January 12, 2016

IGES Project No. 02132-002

Subject: Response to Review Comments - Engineering
Geotechnical Investigation Report and Soil Nail Wall
Lot 39R of Powder Mountain Resort
8365 East Summit Pass
Weber County, Utah

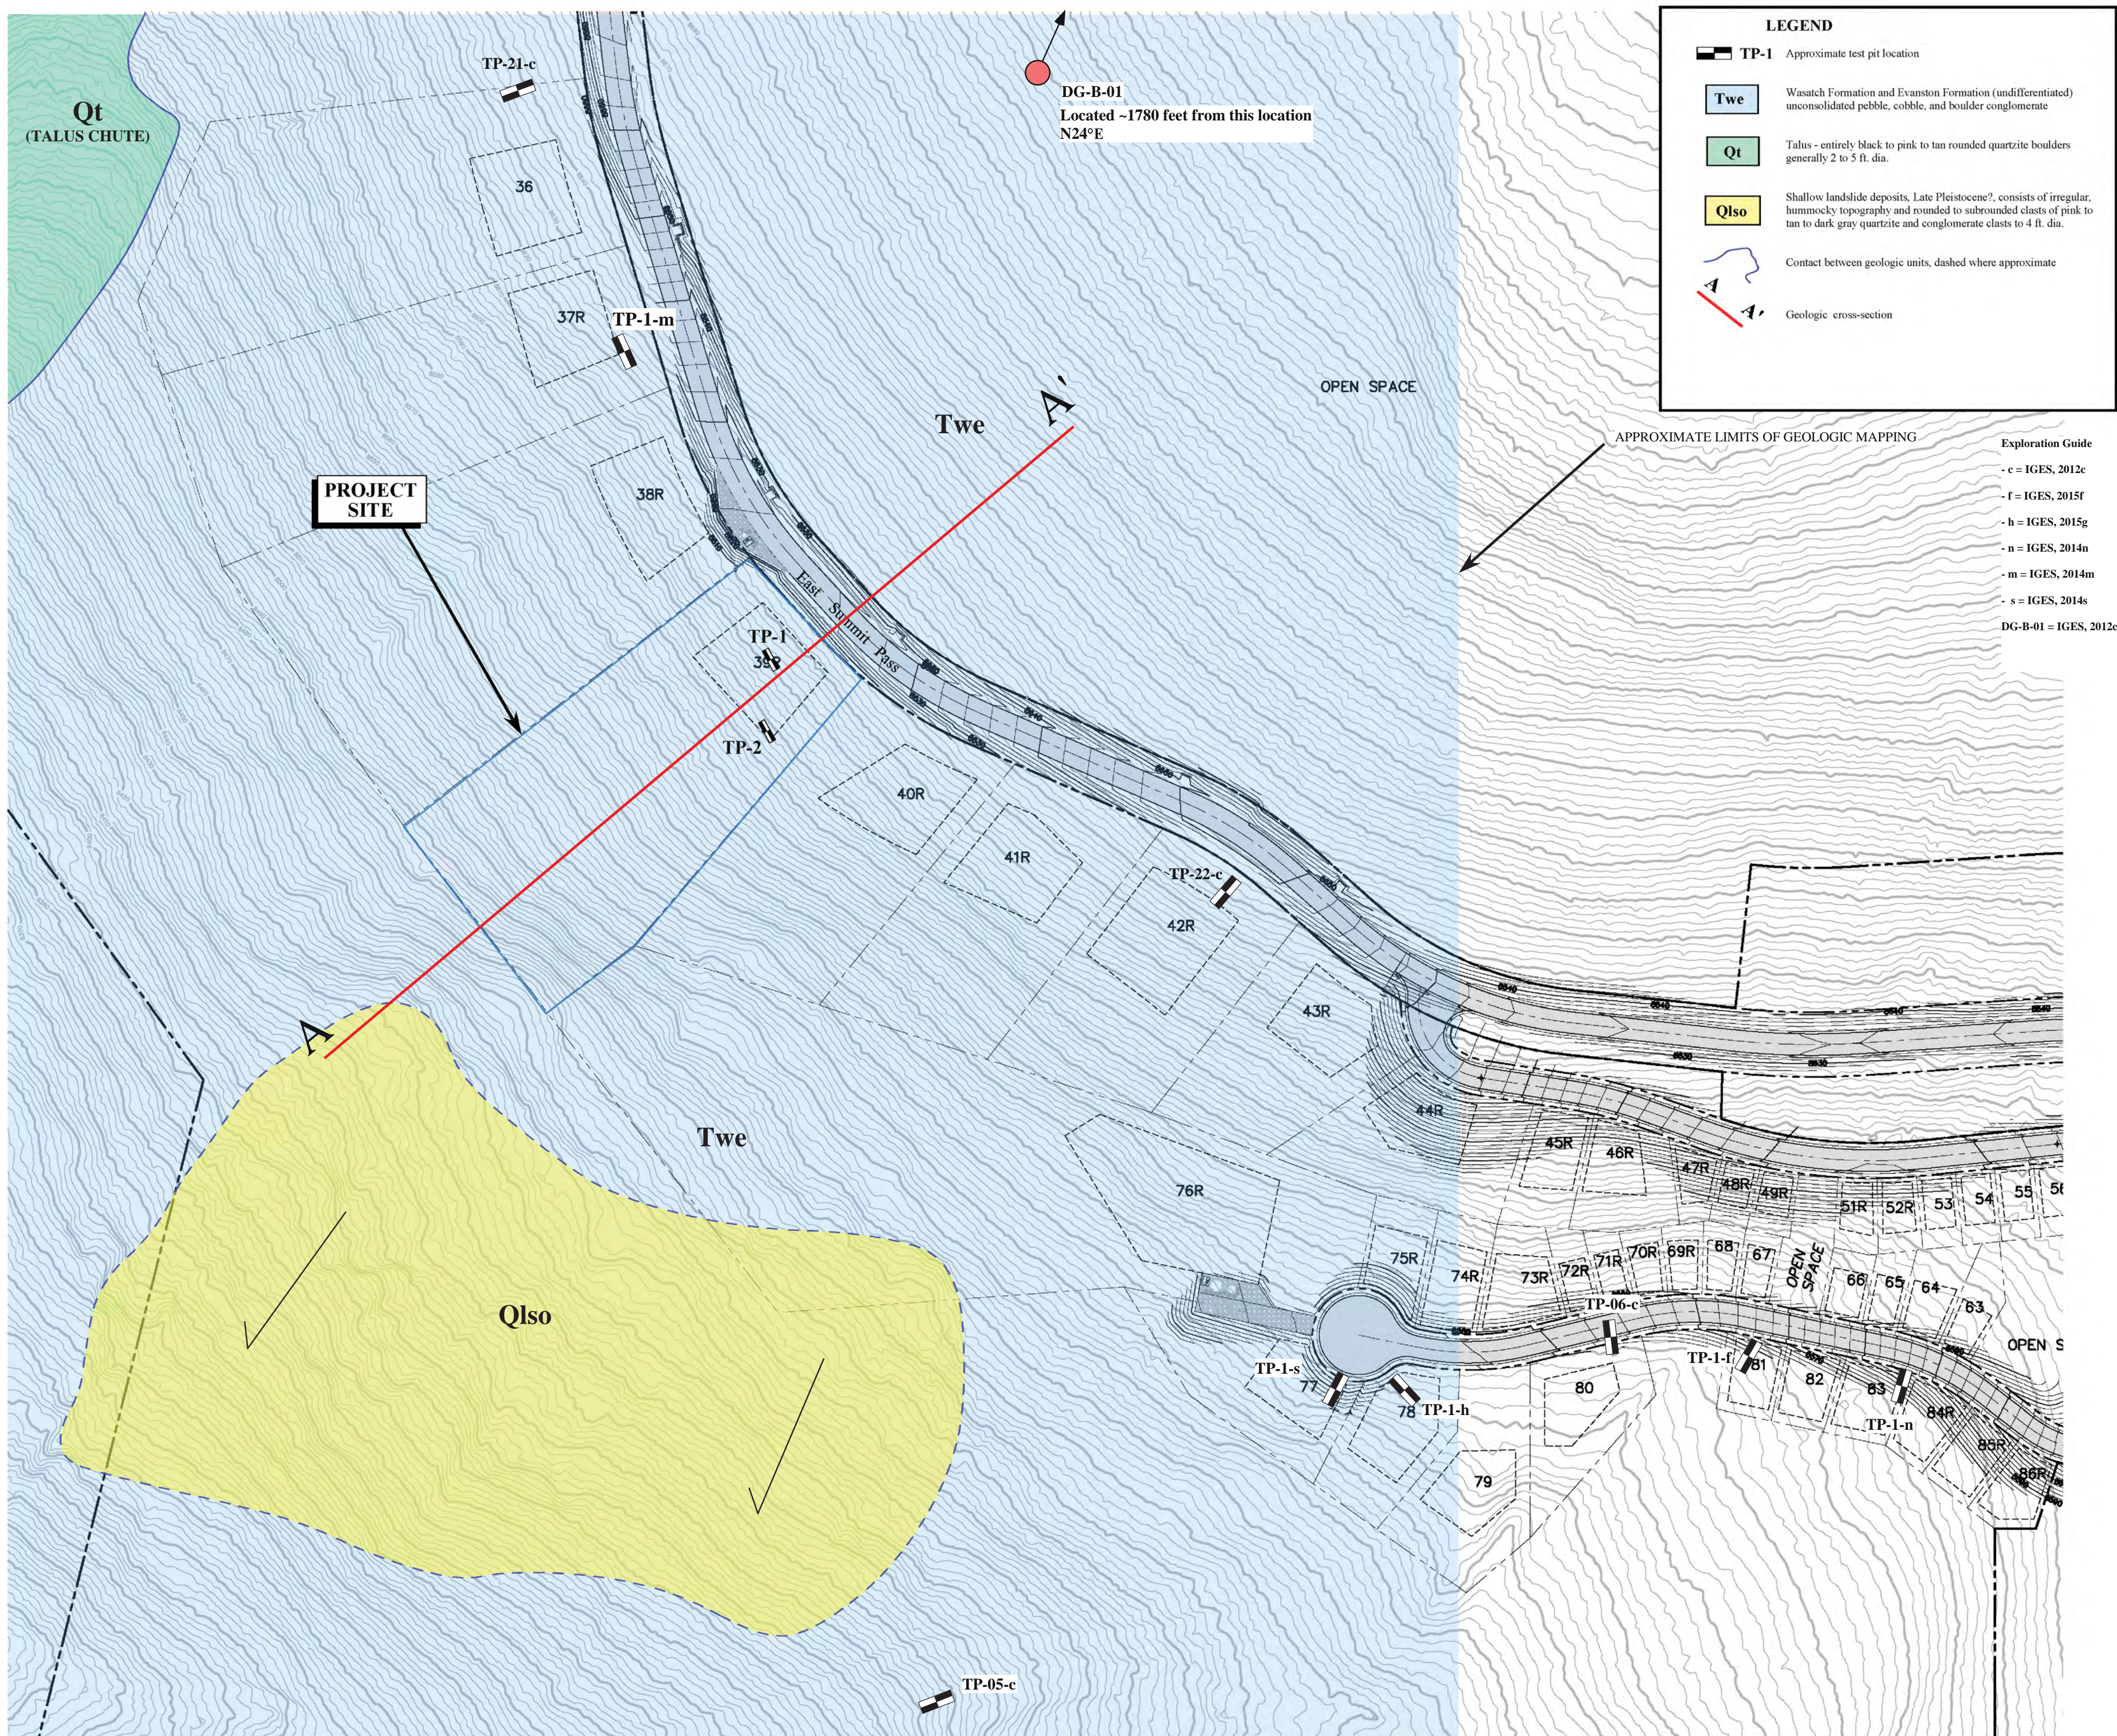
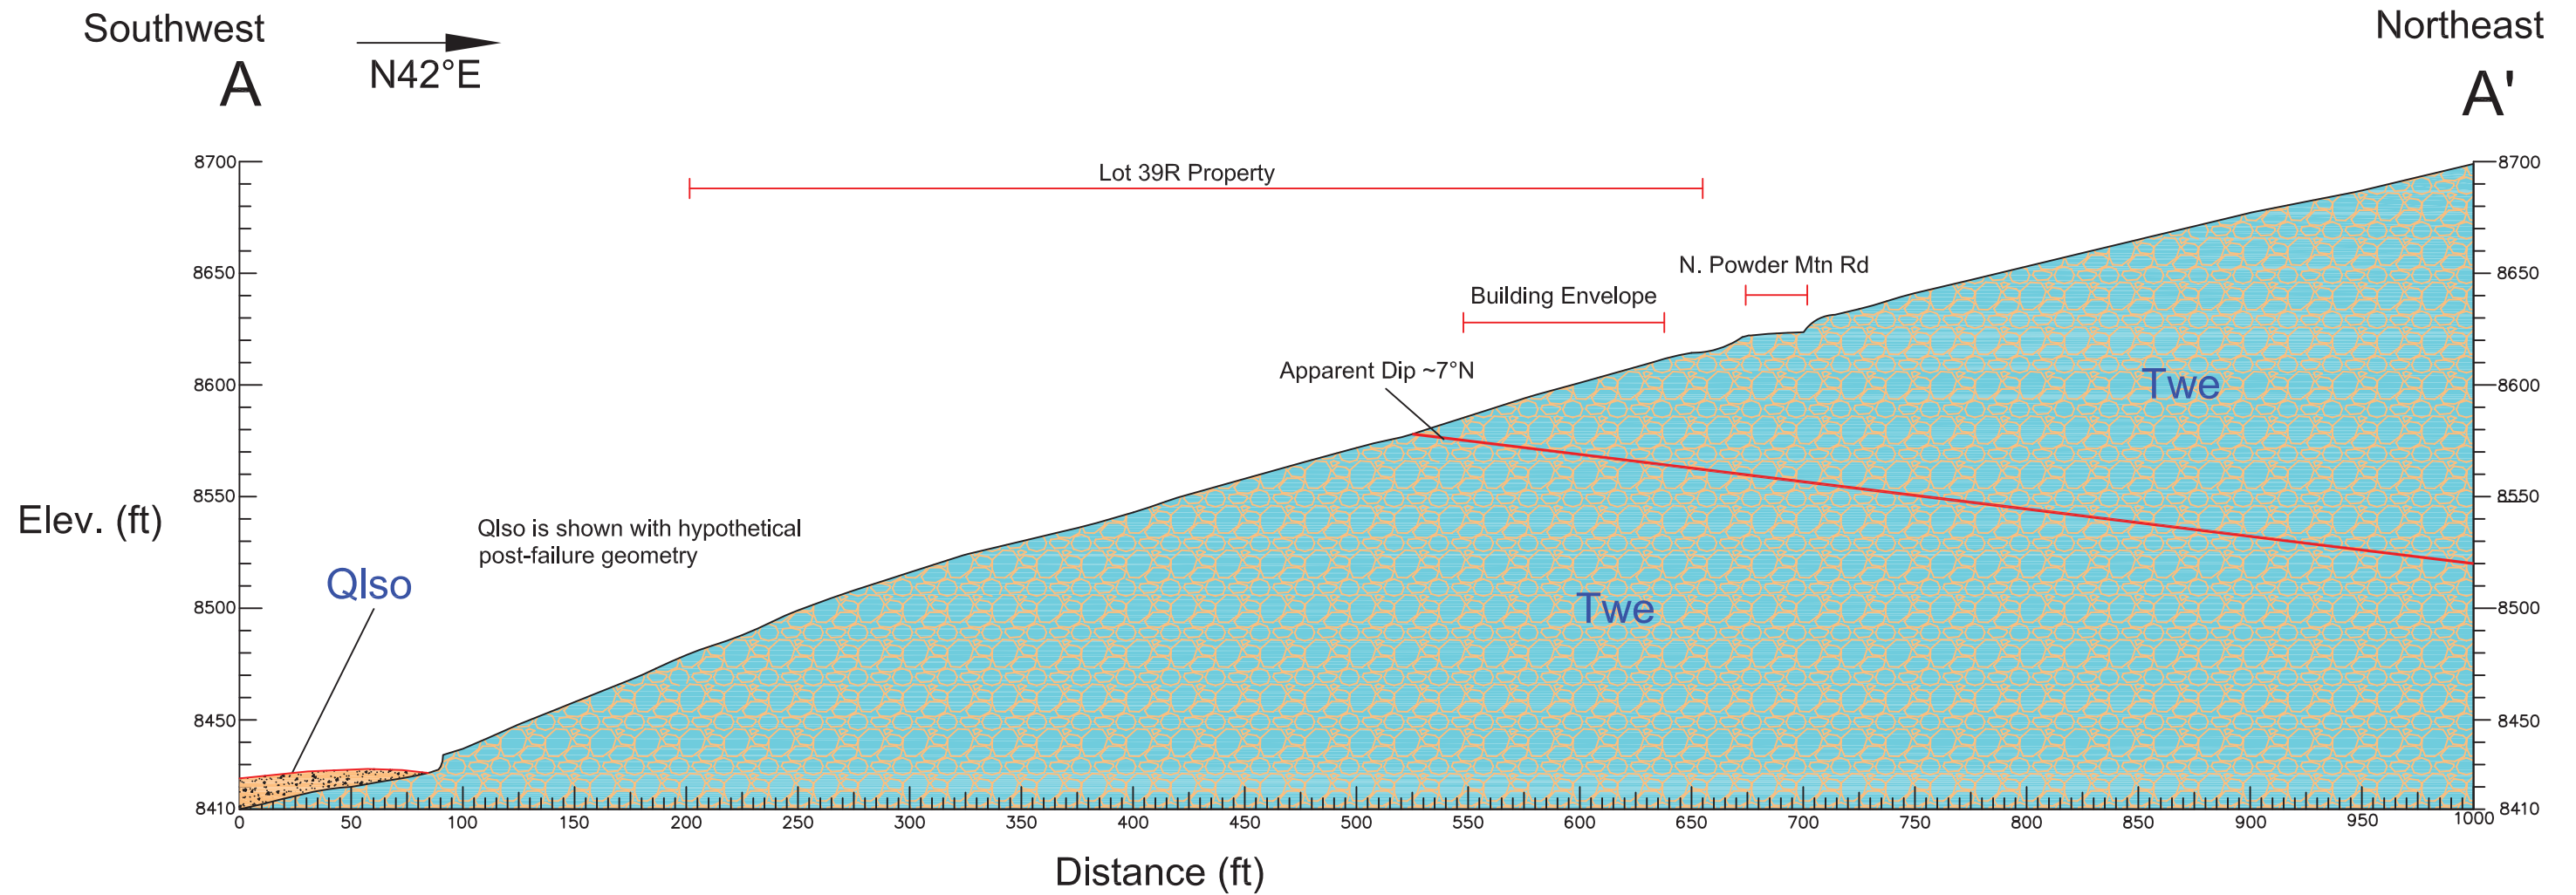
- A. What constitutes “... available geotechnical data.”*
- B. What is IGES’ specific experience in the area allowing “appropriate engineering parameters” to be selected.*
- C. Locations and subsurface conditions, relative to the subject site, of prior IGES projects from which “appropriate engineering parameters” were selected.*
- D. Laboratory data that substantiates the soil parameters used in the analyses presented in the May 8, 2013, and September 17, 2015, IGES documents for the shoring and rock retaining wall designs.*

A map illustrating our subsurface explorations relative to Lot 39, with corresponding logs, is attached (Plate 1).

FIGURE 2

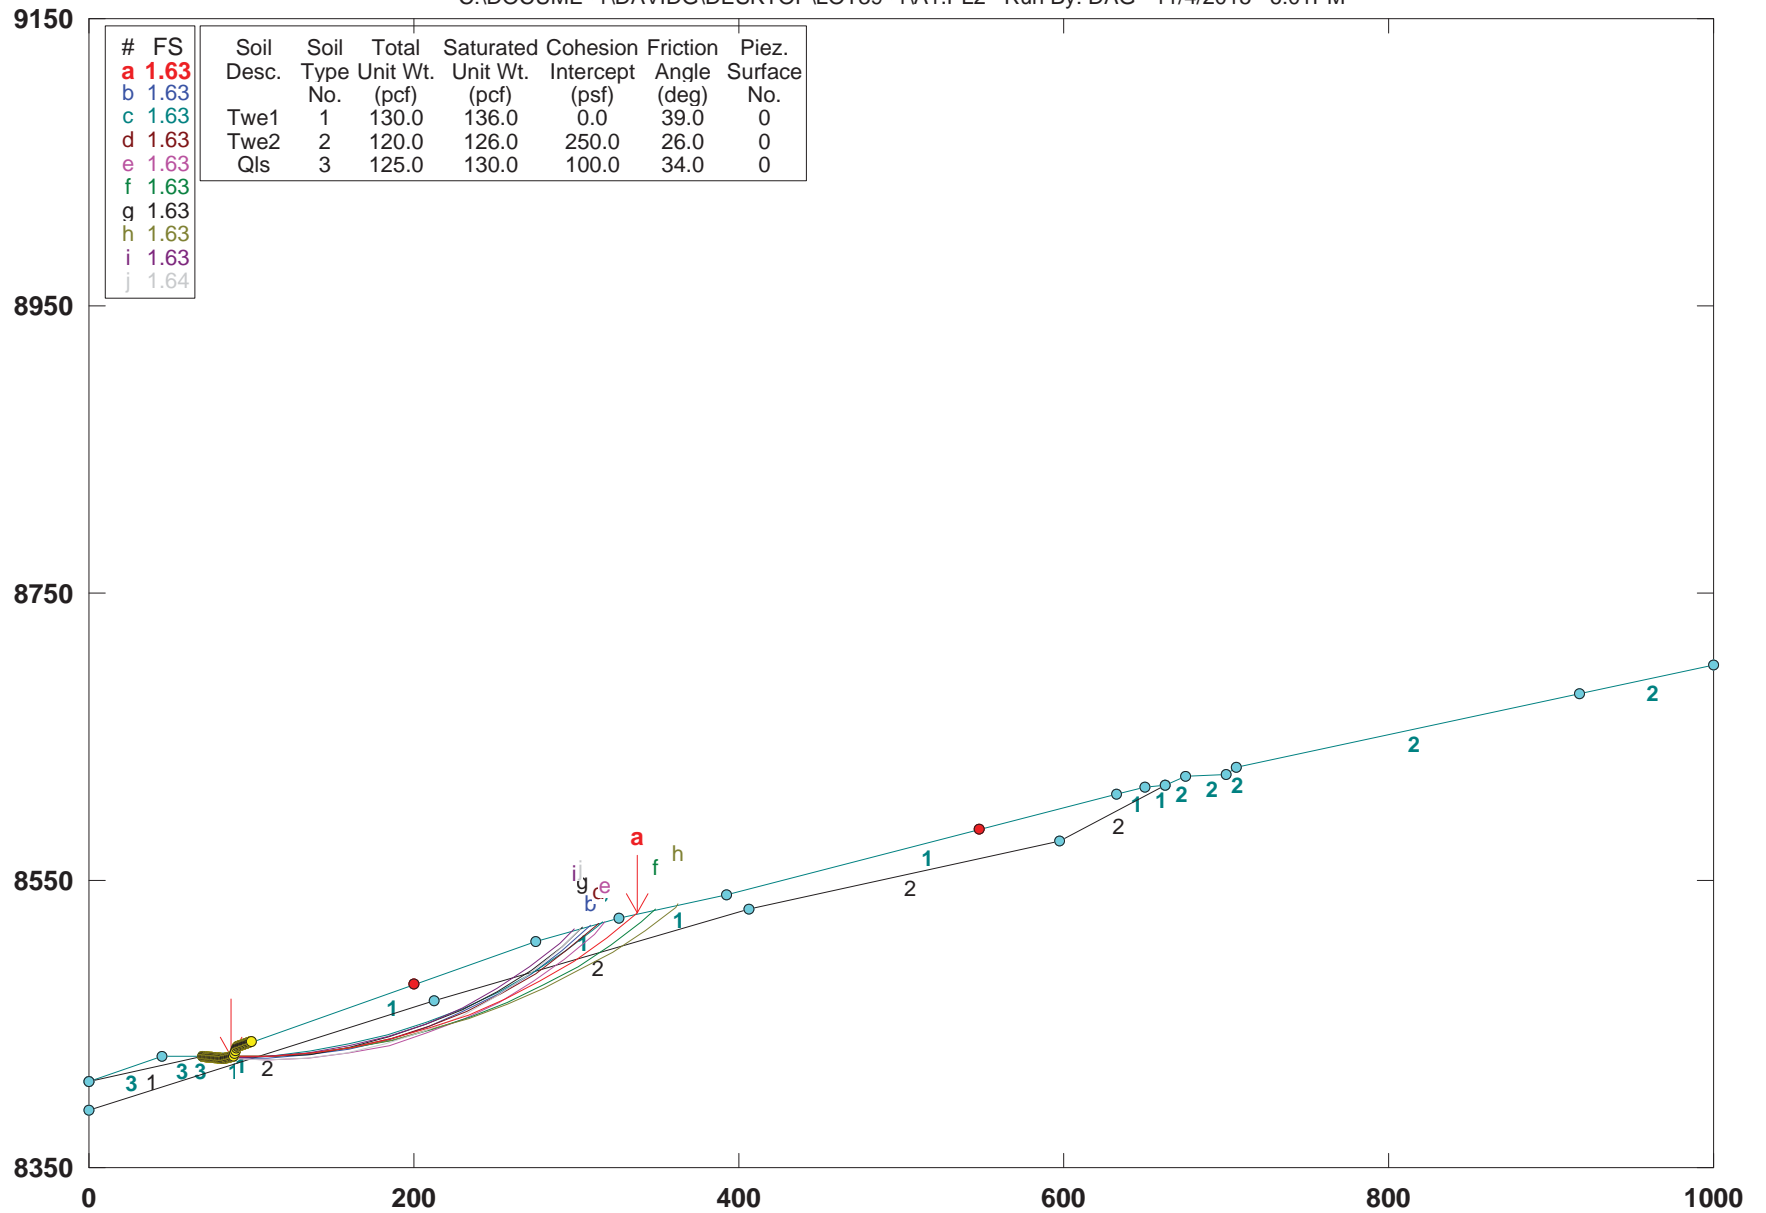
Comment No. 4

“Provide slope stability analyses for all slopes below the building envelope that have a gradient ≥ 20 percent in accordance with the recommendations presented on page 12 of the August 28, 2012, Western Geologic report. IGES states the following on page 1 (under Response to Comment No. 1) of the September 23, 2015, IGES letter:

As a part of our response to geology review comments for Lot 39, IGES performed a slope stability analysis to provide a quantitative assessment of a reasonable setback from the landslide located south of the lot. The intent of the analysis was to model a hypothetical post-failure scenario, e.g., if the mapped landslide is reactivated, what is the potential impact up-slope of the landslide? This analysis provides a reasonable assessment of the stability of the slope below the proposed building envelope, and is therefore reproduced herein.

The stability of the slope was modeled using gSTABLE7 slope stability software. Bishop’s Simplified Method was used to model the slope. Calculations for stability were developed by searching for the minimum factor-of-safety for a circular-type failure. A minimum static factor-of-safety of 1.5 and seismic factor-of-safety of 1.0 was considered acceptable for this project considering the available information. Homogeneous earth materials (existing site soils, colluvium) and arcuate failure surfaces were assumed. The section analyzed is Section A-A’, illustrated on Plate 1 (attached). Geologic Cross Section A-A’ is presented as Figure 1, attached.

Based on our analysis, in a hypothetical post-failure condition, minimum factors-of-safety of 1.5 and 1.0 for static and seismic conditions, respectively, are maintained with respect to the proposed building envelope. Therefore, the distance between the proposed building envelope and the mapped landside is considered acceptable from a slope stability and geologic hazard standpoint. The results of the global stability analyses are attached.
